ADDENDUM 2

PROJECT: Eugene School District 4J
Chinese Immersion Program Site & Building Renovation
at Kennedy Middle School (202014)
Eugene, Oregon

DATE: February 11, 2021

RE: Changes, Revisions, Clarifications and Additions

**CIVIL
DETAILS**

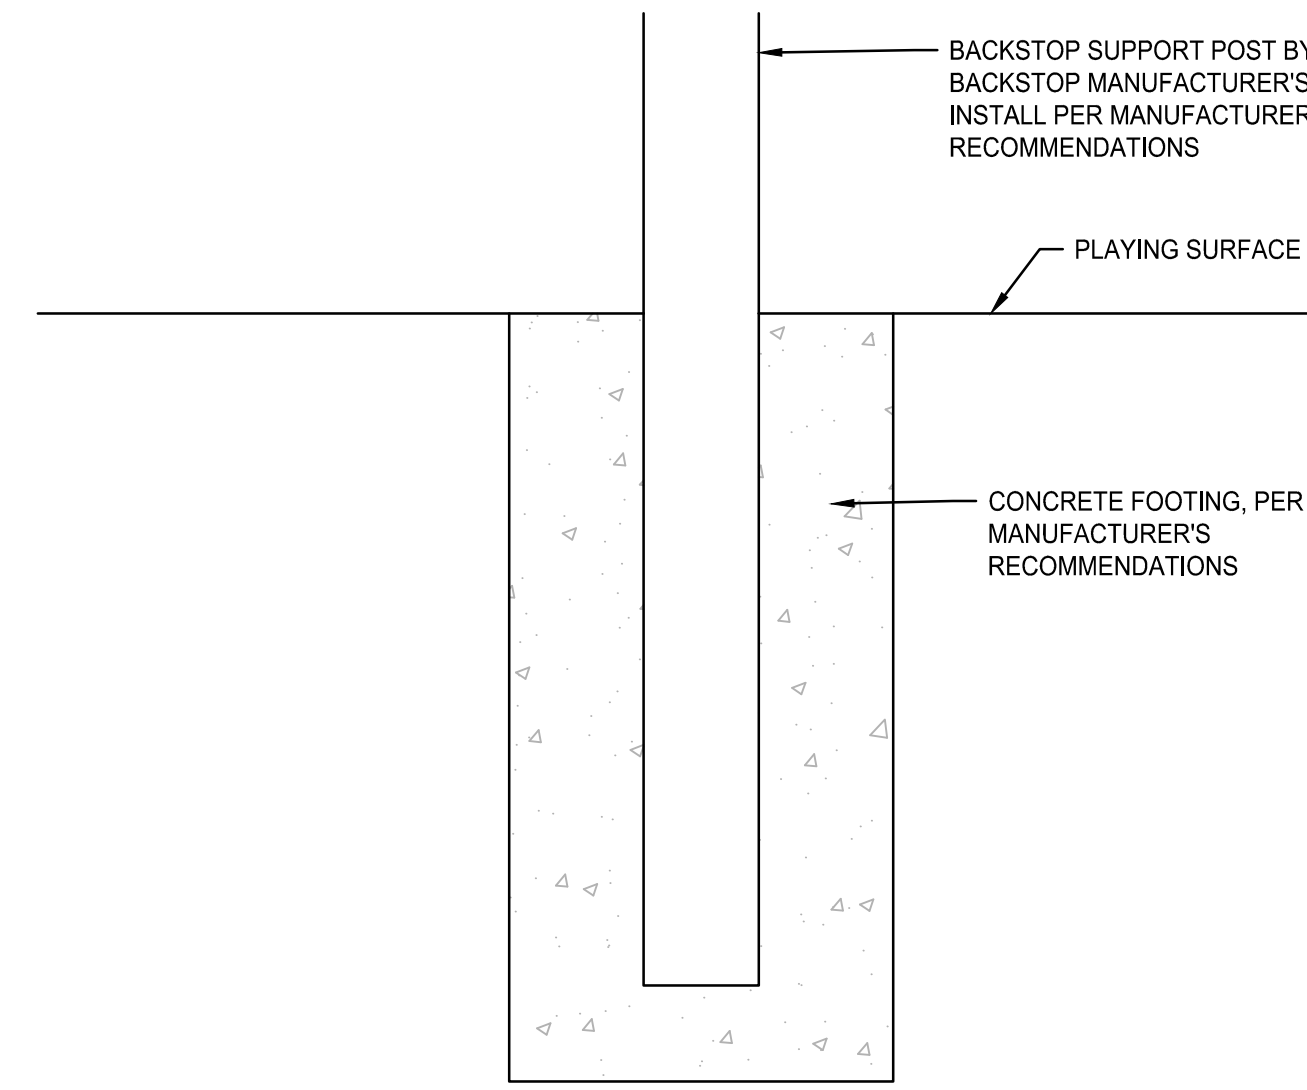
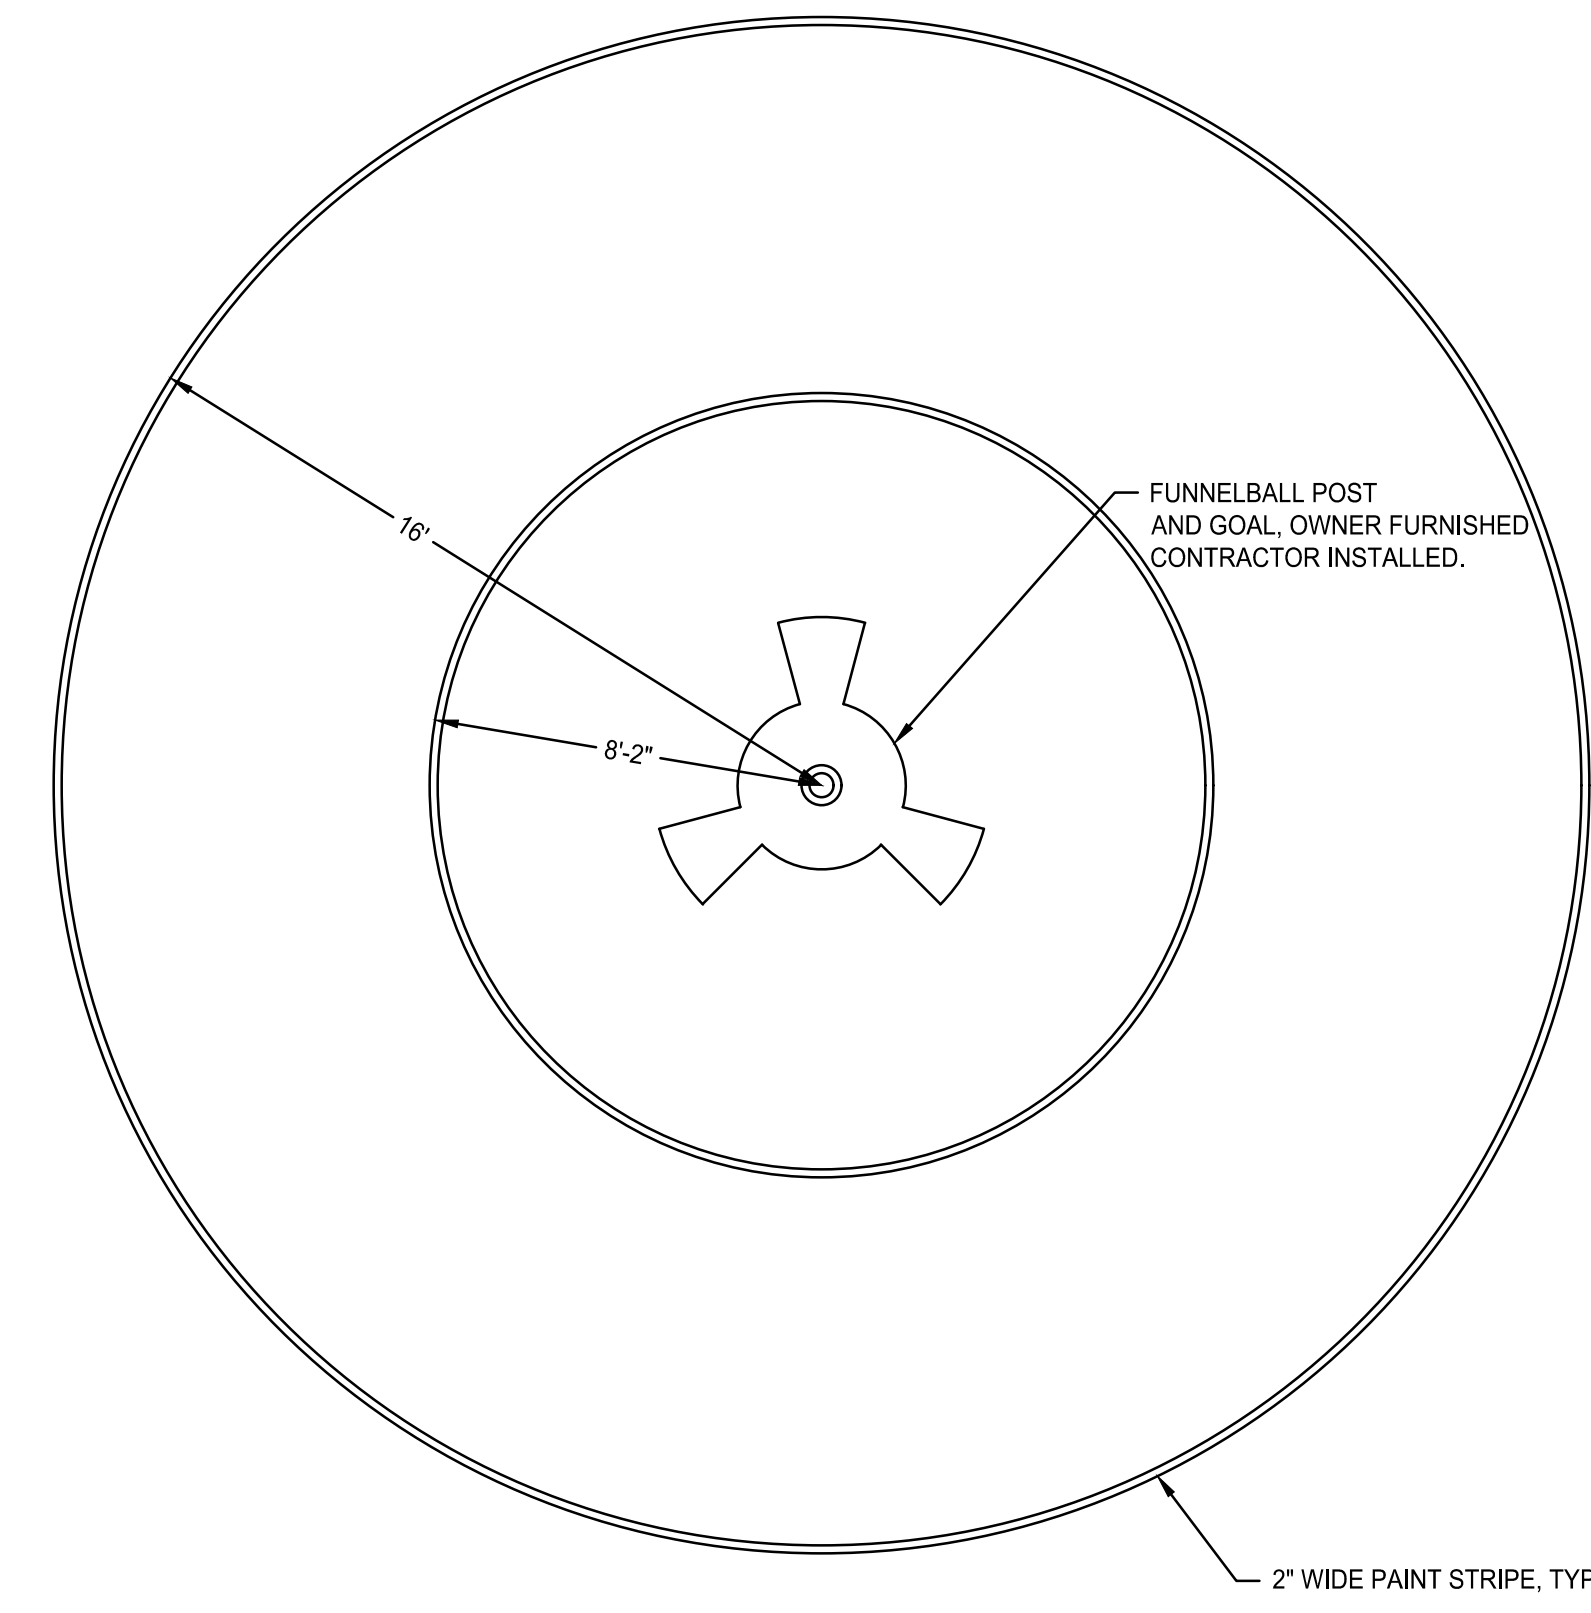
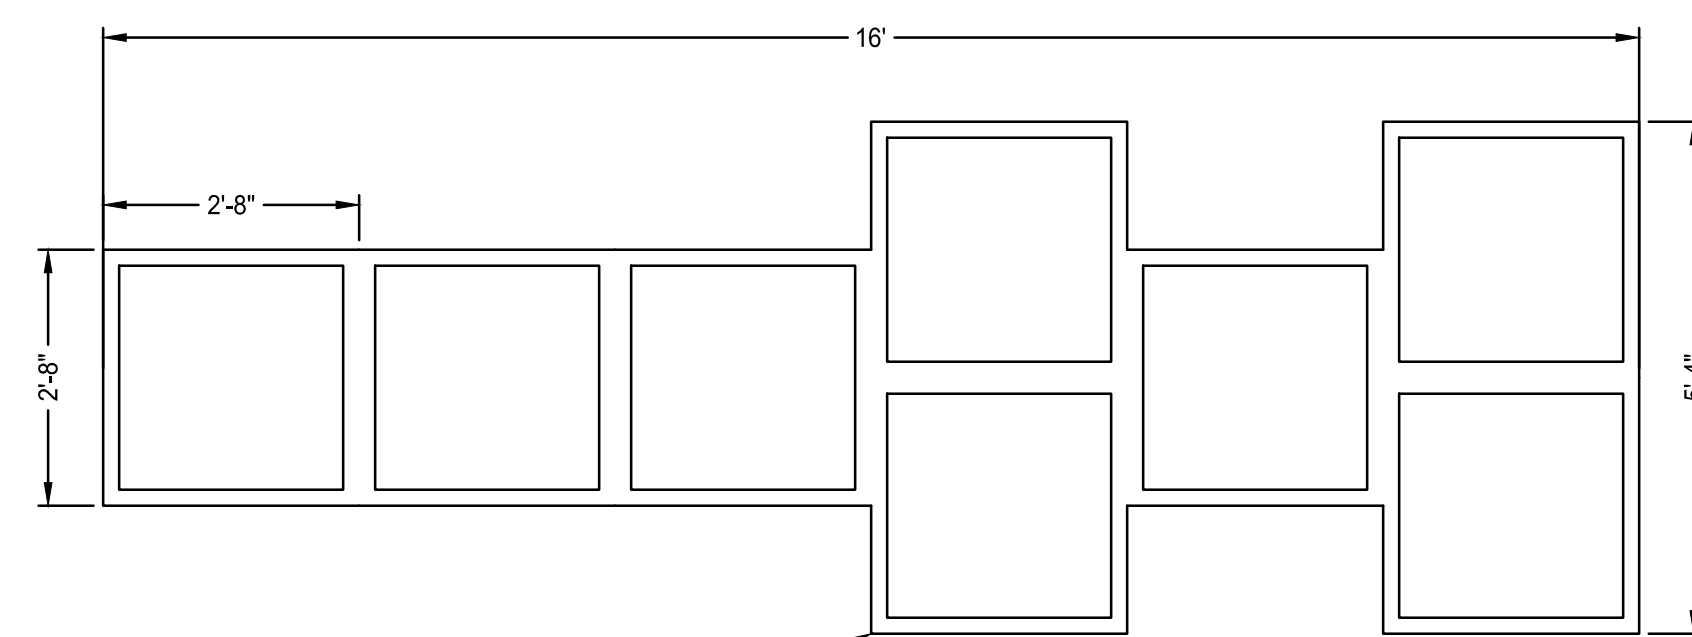
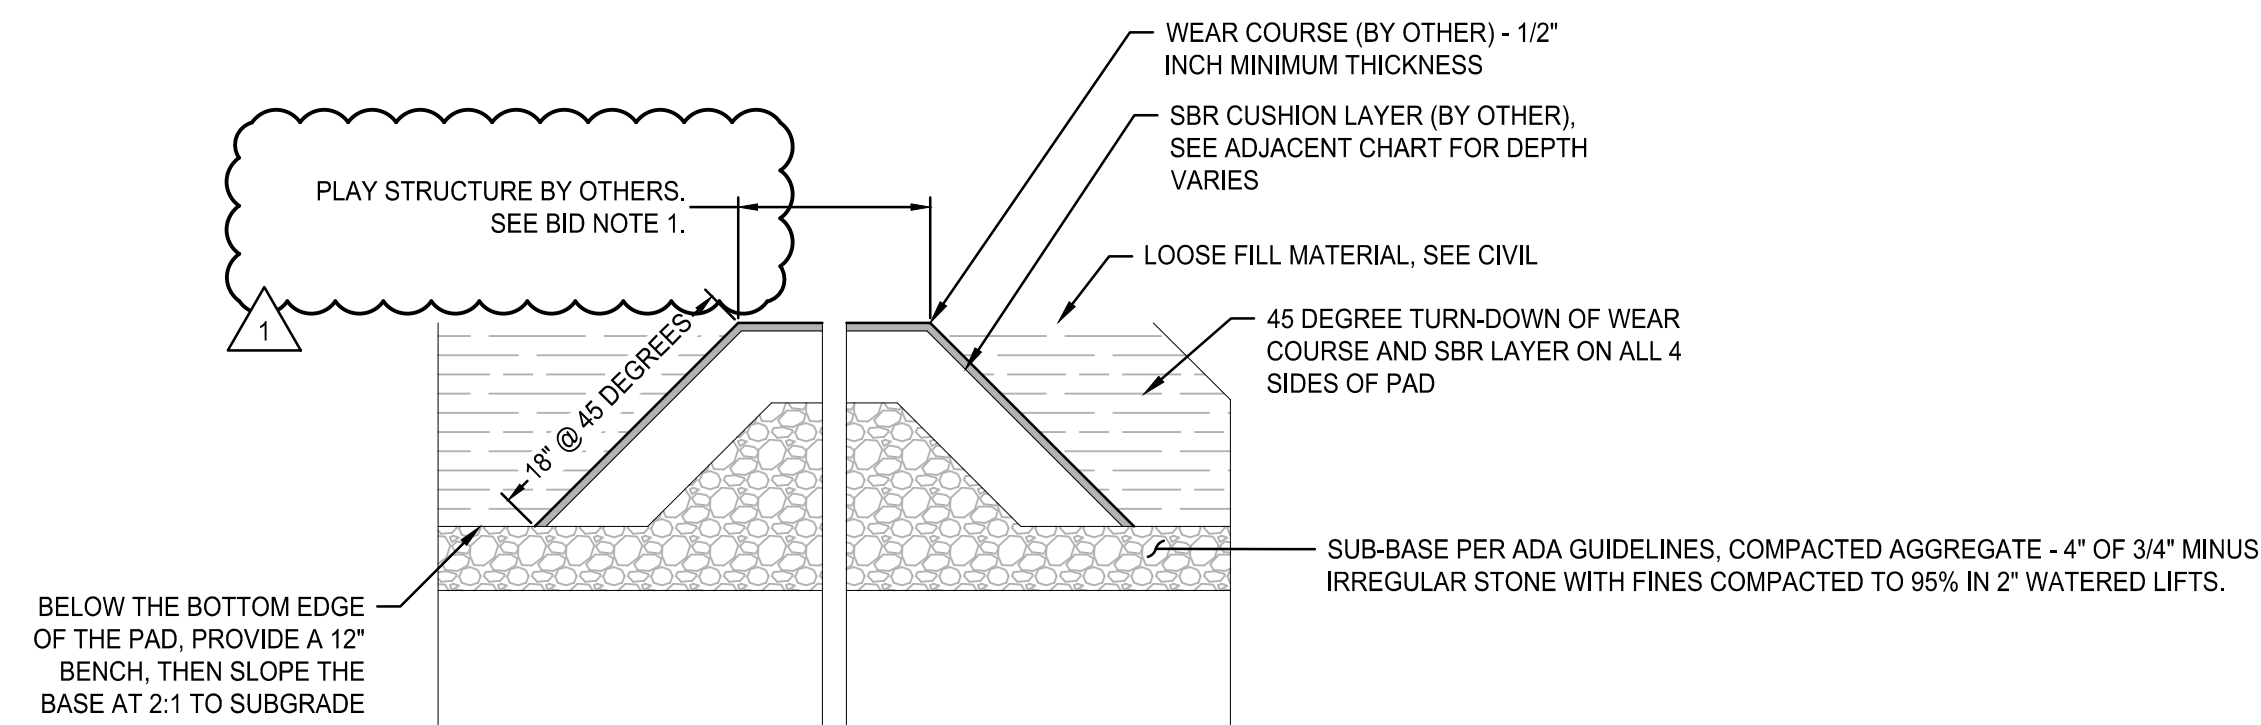
- Item 17: Reference Sheet C5.2 – CIVIL DETAILS dated January 27, 2021: Delete and replace with attached Sheet C5.2 – CIVIL DETAILS with revisions dated February 10, 2021.
